Clonburris SDZ, Reg ref: SDZ22A0010
Dublin 22

Ronan Mac Diarmada & Associates

COMPLIANCE RESPONSE

July 2023

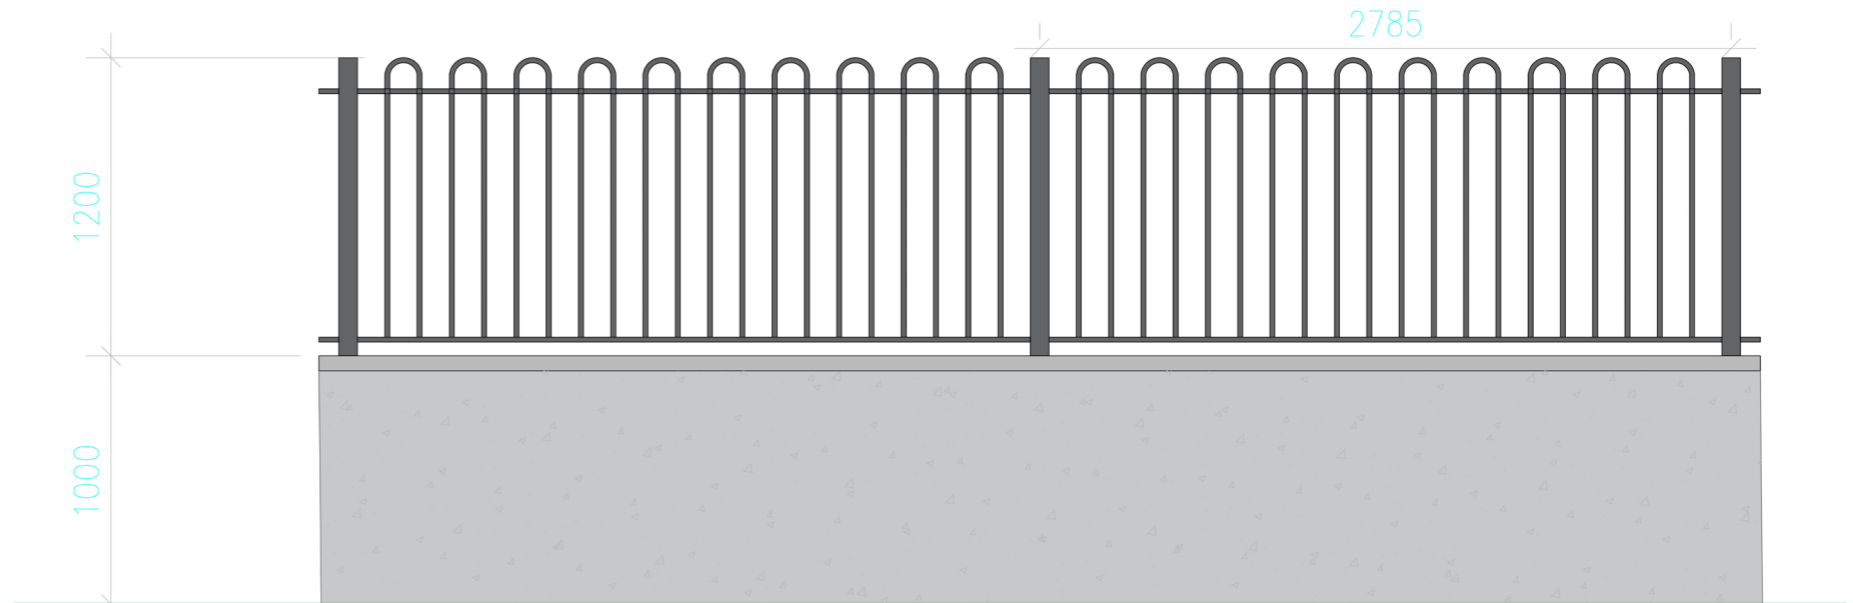
Revised boundary plan clearly showing the proposed boundary treatments for the scheme. The northern and eastern boundaries should be revised so that any boundary walls along these boundaries are no more than 1.0m in height. Planting and landscaping shall be reduced in height and/or provide for adequate passive surveillance.

Please refer to Dwg02 Boundary Plan, for more details on boundary treatments in the scheme. The northern boundary wall has been reduced in size as per request. A native hedge shall be planted to the inside of the wall.

1.0m high Rendered Wall with 1.2M high Bowtop Metal Railing Galvanised, Powder Coated Black

Proposed Landscape Plan

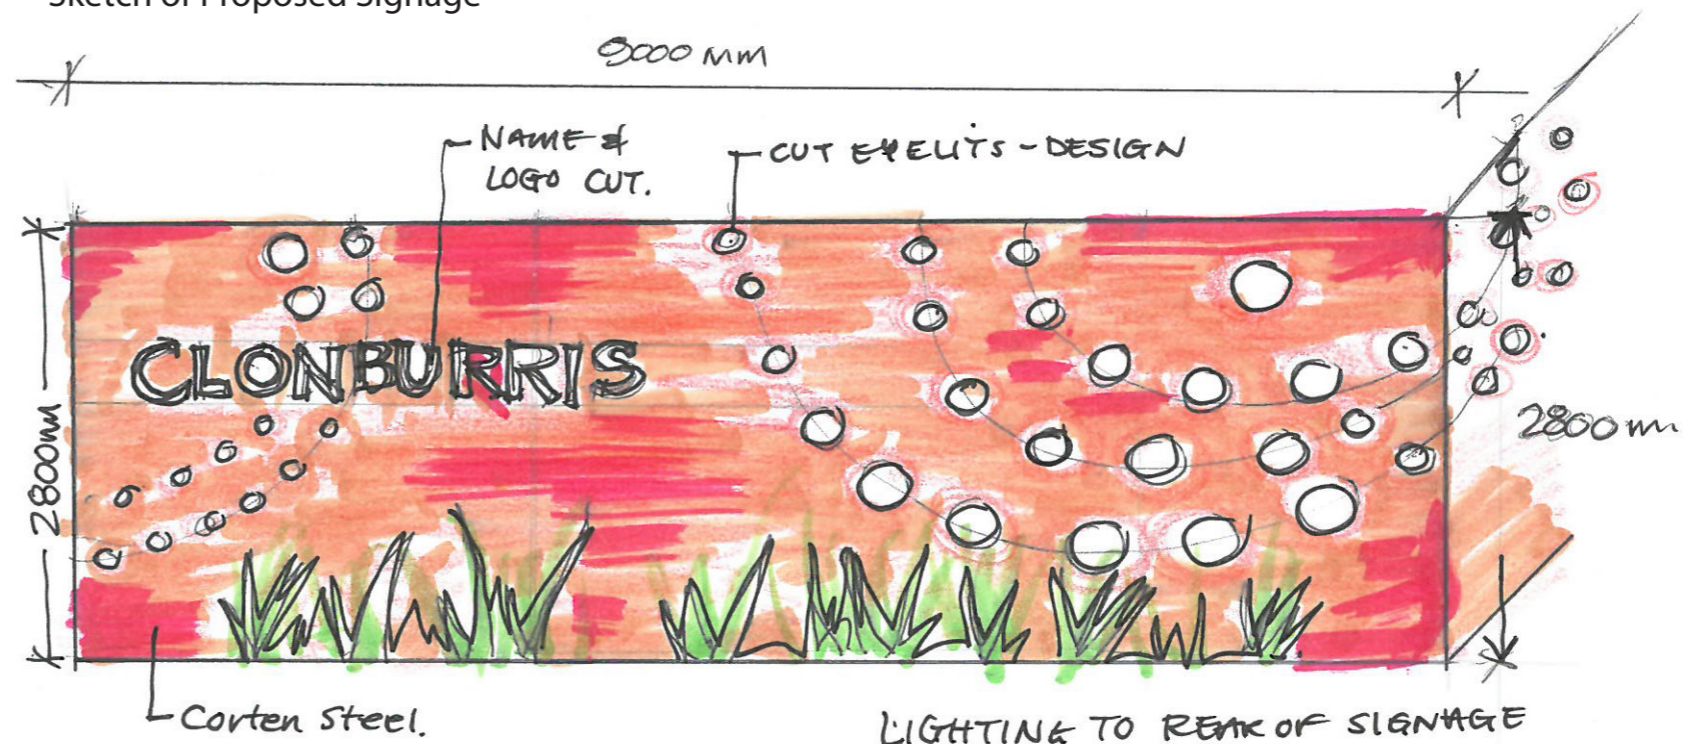
The plans shall provide for green infrastructure/landscaping to improve the link between the southern hedgerow and the central north-south hedgerow.

Please refer to Dwg01 Landscape Plan, for more details on green infrastructure and landscaping. We have provided native hedge mix to mitigate any loss to existing hedgerows and wildflower meadow to enhance the existing biodiversity. Bio-swales in the open space will contribute to the SuDS of the overall site.

Sketch of Proposed Signage

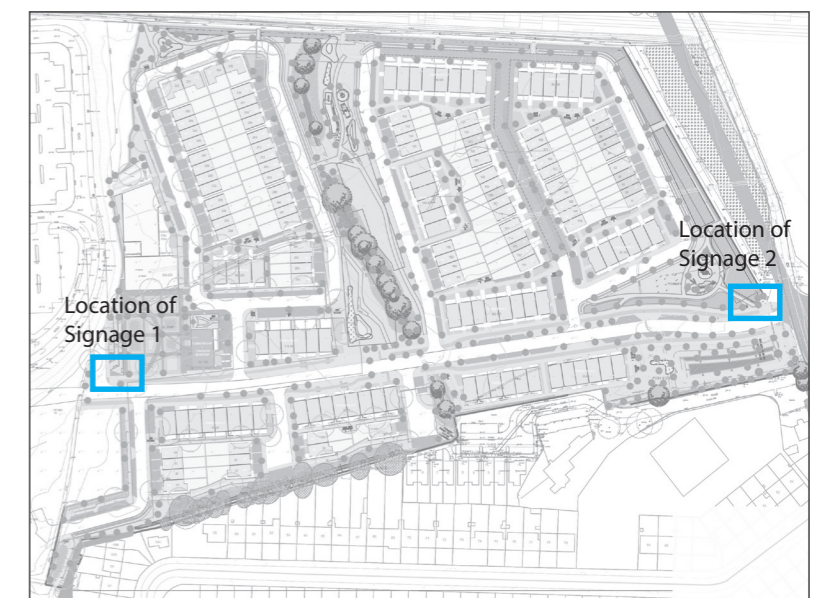
Prior to the commencement of development the applicant/ developer shall submit for the written agreement of the Planning Authority details of all external signage including in the public realm, and relating to the creche and commercial/retail units.
REASON: In the interest of the amenities of the area/visual amenity.

Details of external signage included in the public realm, and relating to the creche and commercial/ retail units are to be provided by the creche.

RMDA have proposed 2 Entrance signs in the site. Please refer to the proposed sketch and images on this page. We have propose corten steel signage.

Eastern Green Corridor

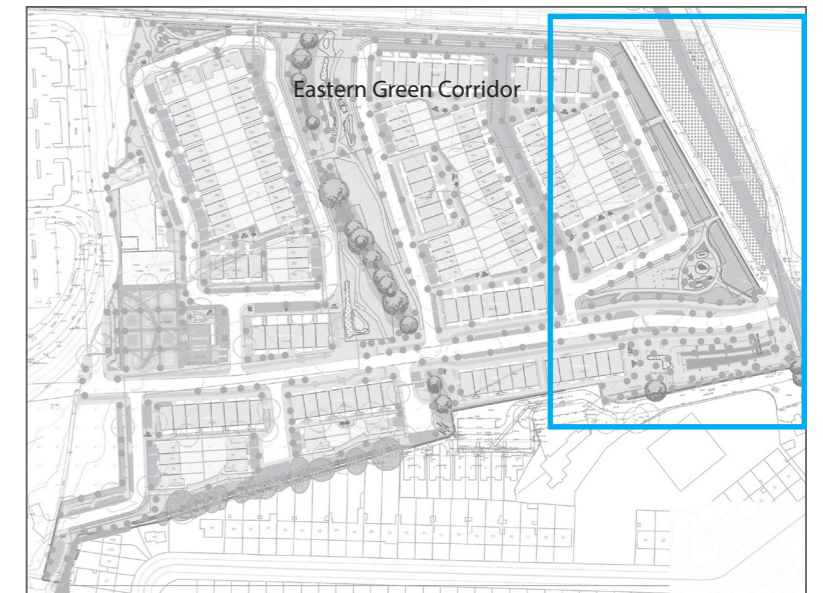
(ii) A Local Green Corridor approximately N-S along the eastern boundary incorporating nature based SuDS and planting along the length of the boundary.

(ii) A Local Green Corridor N-S along the eastern boundary has been provided with the use of Wildflower meadow planting and swales along the roadside. Street tree planting will also line the open space.

Central Green Corridor

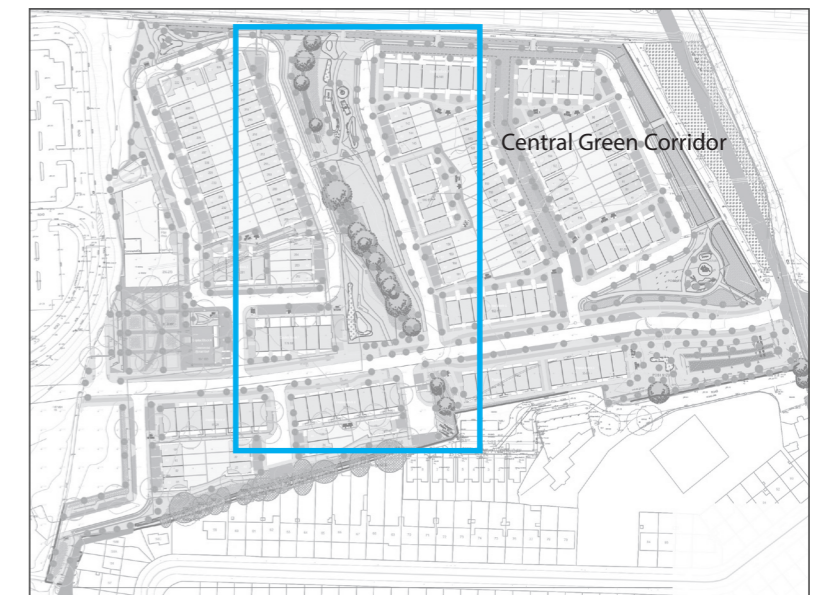
(iv) A Local Green Corridor approximately N-S through the centre of the development increasing the tree planting and providing above ground SUDS.

(iv) A Local Green Corridor approximately N-S through the centre of the development has been provided with the use of Wildflower meadow planting and swales along the roadside. Native hedge species will be used to mitigate any loss of the existing hedgerow.

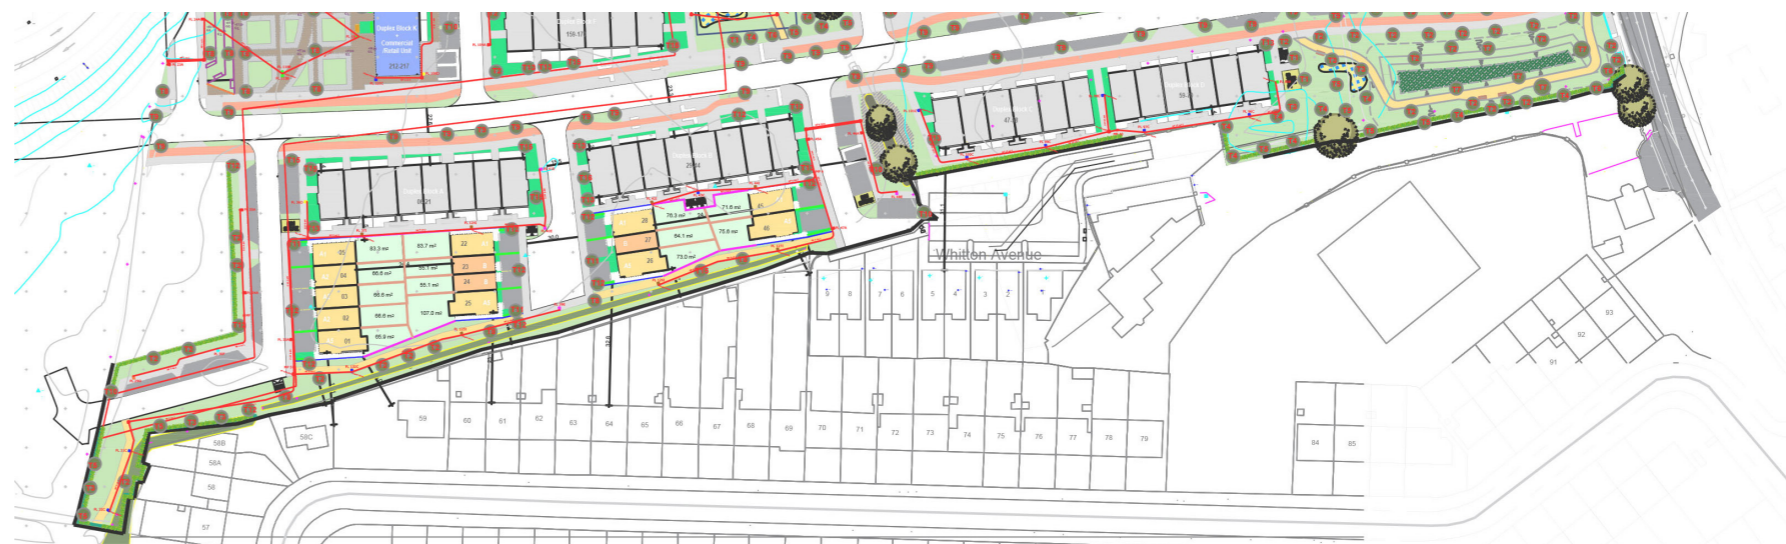
(v) Retention of trees and hedgerow along southern boundary as shown in SDZ. Where hedgerow was removed this is to be replaced with fast growing planting, such as Miyawaki-style planting. No tree works/removals or pruning to take place prior to a site meeting with Public Realm to agree extent of works. No works to take place within the root protection zone/drip line of trees. An area of Public Open Space is required between the hedgerow and the development to allow proper setback for residential amenity and to allow for the Taking in Charge and maintenance of the trees and hedgerow in the future (space for tractor and flail required - minimum space required 6m from base of hedgerow). This should involve either changing the house/dwelling-unit type or omitting House Nos. 01, 25, 26 and 46. The ESB substation adjacent to the southern hedgerow shall be moved elsewhere in the scheme.

(v) The southern boundary hedgerow and existing trees has been retained in its majority as agreed with SDCC. Native Hedge & Tree species will be used to mitigate any loss occurred in this space.

Following an Arborist Survey, a root protection zone and fencing will be erected to protect the existing trees before any works are done.

The residential layout to the southern boundary has been revised to allow a setback for residential amenity and to allow for the Taking In Charge and maintenance of the trees and hedgerow in the future. The ESB substation location has also been revised to reduce impact on central hedge.

There was a meeting with Mr Laurence Colleran of SDCC Parks Department as the extent of construction of houses. A number of houses were removed to facilitate the existing trees & hedge along the southern boundary.

Several houses have been removed from the southern boundary to retain the existing hedge.

To mitigate any loss of trees or hedge, native tree and hedge mix will be planted to enhance the existing vegetation.

Tree Pit Build Out Detail 1:50

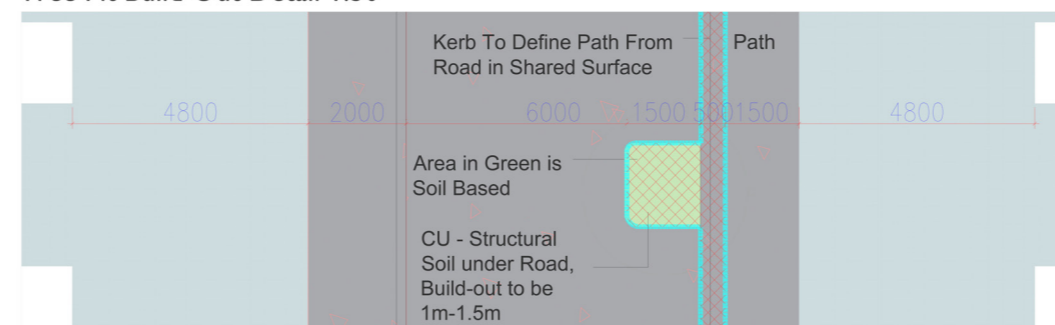
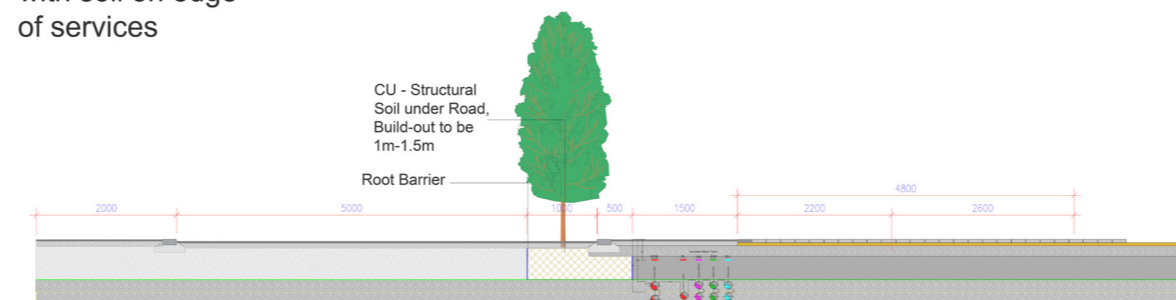
(a) Street trees required at the following locations: Outside house numbers: 192, 194, 196, 200, 202, 203, 190, 191, 189, 188, 187, 185, 183, 181, 179, 177, 175, 174, 172, 125, 126, 127, 129, 131, 133, 135, 137, 139, 140, 142, 107, 109, 111, 113, 115, 117, 119, 121, 122, 124, 123, 92, 90, 89, 87, 85, 83, 82, To enable the tree to be in the street the footpath should be moved to the inside, (i.e. car parking and tree on the street edge).

(a) Street trees have been provided where possible outside the house numbers mentioned above in the item. With agreement with SDCC, street trees will be provided in tree pits, approximately every 20m along the roads. Please refer to section of tree pit, with buildout to roads.

Eastern Green Corridor

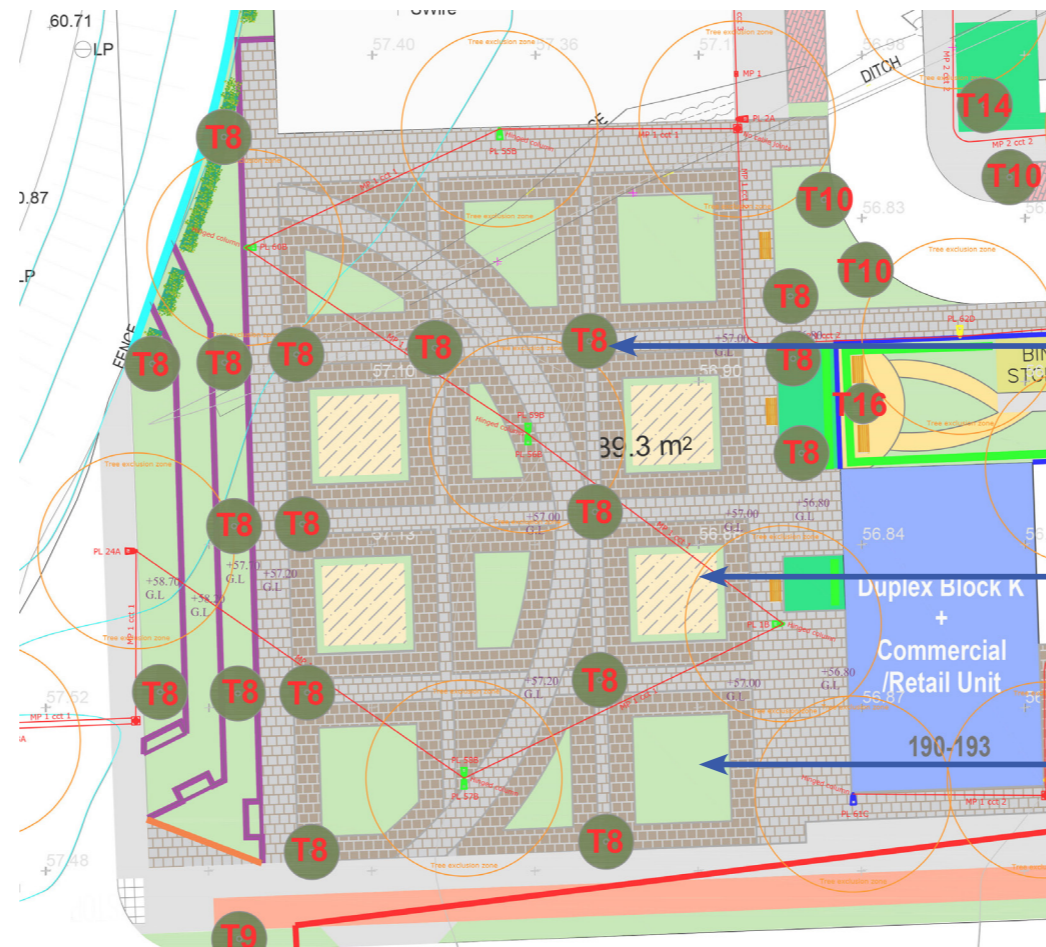
(b) Additional street trees required to address the gap in street tree provision along the Local Green Corridor connecting the canal to the urban plaza. Enhanced planting shall be provided by additional street trees, planted swales or small scale SuDS as appropriate to create a Local Green Corridor along this street. The applicant is referred to the Clonburris SDZ Planning Scheme 2019, Clonburris SDZ Parks and Landscape Strategy and DMURS (2019) for guidance on street tree provision and appropriate design layouts for local streets and homezones.

All Street Trees planted within the Public Realm shall have suitable tree pits that incorporates SuDS features including sufficient growing medium. Street Trees to be planted at:

- Minimum 18-20m girth along local streets
- Minimum 16-18cm girth on intimate local roads, i.e. homezones.

Landscape masterplan/planting plan to clearly delineate street lighting to ensure street tree proposals are realistic. If this is not currently the case, proposals to be revised to ensure street tree delivery.

(b) Street trees have been provided along the Local Green Corridor, connecting the canal to the urban plaza with the use of wildflower meadow planting and native tree species.

SuDS features such as swales and tree pits have been accommodated along these streets. Wetland planting and suitable tree species will be provided within the swales.

All street trees that are planted within the public realm will have a tree pit incorporating SuDS features. Please refer to tree pit detail shown.

Street trees will be 18-20cm on the local streets, & 16-18cm on intimate local roads, i.e. homezones.

The revised landscape plan incorporates the revised street lighting, ensuring the tree planting proposals are realistic. A 5m exclusion zone has been provided to mitigate any potential clashes with the tree planting plan.

Proposed Plaza Area

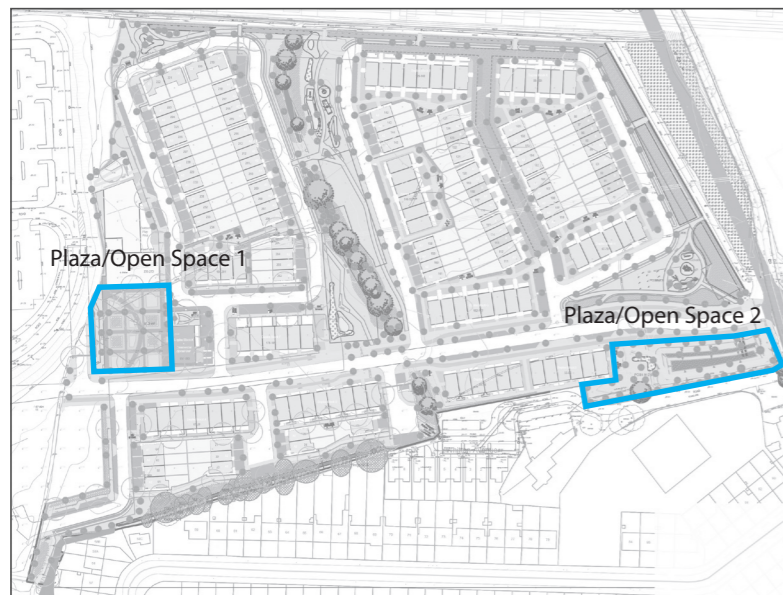
- (i) Revised design for plaza incorporating Green Infrastructure and natural SuDS
- (ii) Revised design of Public Open Space with detention ponds to incorporate shelves and planting.

- (i) The design for the plaza has been revised to incorporate natural SuDS and green infrastructure. The trees shown in the plaza will have tree pits included. Areas of grass/meadow mix will allow water to drain into these spaces.
- (ii) As per coordination with the Engineers, the Public Open Space to the South-East of the site will incorporate shelves and wetland planting.

Central Open Space

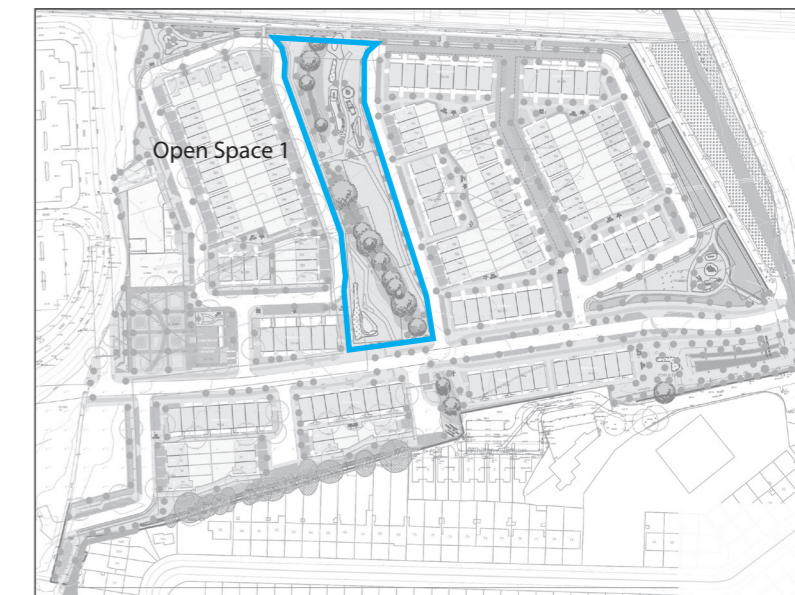
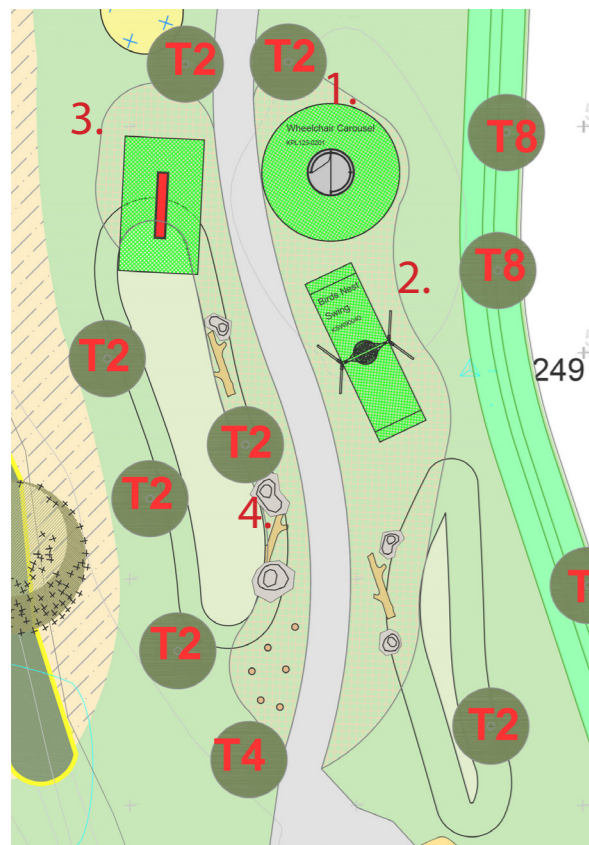
- (iii) Revised open space and play design on open space in east of site, north of link road.
- (iv) Revised play design at central open space
- (v) Open space areas along all roads to incorporate natural SuDS for attenuation, water treatment, amenity and biodiversity purposes as outlined in SDZ. Details of all natural SuDS features including swales, rain gardens, bioretention tree pits, channel rills, filter strips, ponds, detention basins with lower areas allowed to fill first (low flow channels), wetlands etc. to be agreed with Public Realm

- (iii) The open space to the east has been revised. The play equipment and design has been revised to reflect the change in layout. SuDS elements have also been included in the form of swales to the perimeter of the space.
- (iv) The central open space has been revised to incorporate SuDS elements as well as revised play items.
- (v) Open space areas along all roads incorporate natural SuDS for attenuation, water treatment, amenity and biodiversity purposes as outlined in SDZ. Please refer to details shown for treatment of swales and detention basin as per coordination with Engineer.

Eastern Open Space

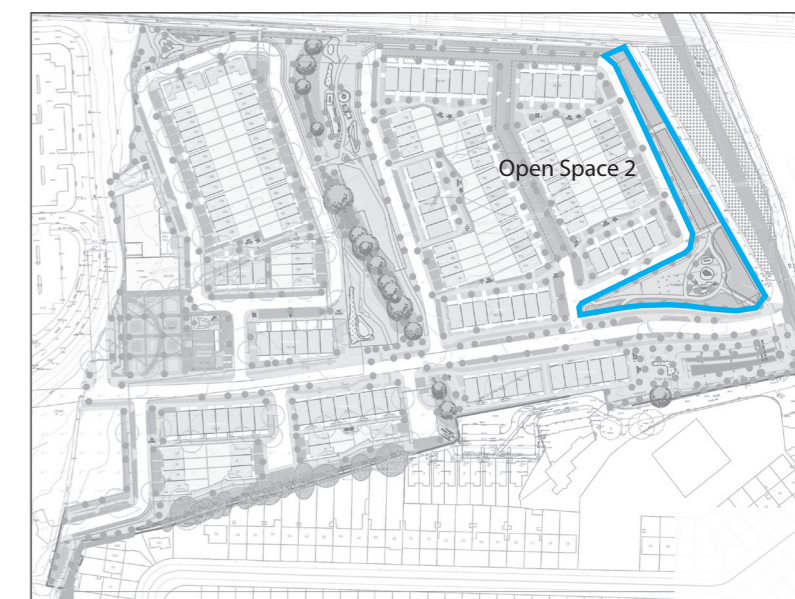
- (iii) Revised open space and play design on open space in east of site, north of link road.
- (iv) Revised play design at central open space
- (v) Open space areas along all roads to incorporate natural Suds for attenuation, water treatment, amenity and biodiversity purposes as outlined in SDZ. Details of all natural SuDS features including swales, rain gardens, bioretention tree pits, channel rills, filter strips, ponds, detention basins with lower areas allowed to fill first (low flow channels), wetlands etc. to be agreed with Public Realm

- (iii) The open space to the east has been revised. The play equipment and design has been revised to reflect the change in layout. SuDS elements have also been included in the form of swales to the perimeter of the space.
- (iv) The central open space has been revised to incorporate SuDS elements as well as revised play items.
- (v) Open space areas along all roads incorporate natural Suds for attenuation, water treatment, amenity and biodiversity purposes as outlined in SDZ. Please refer to details shown for treatment of swales and detention basin as per coordination with Engineer.
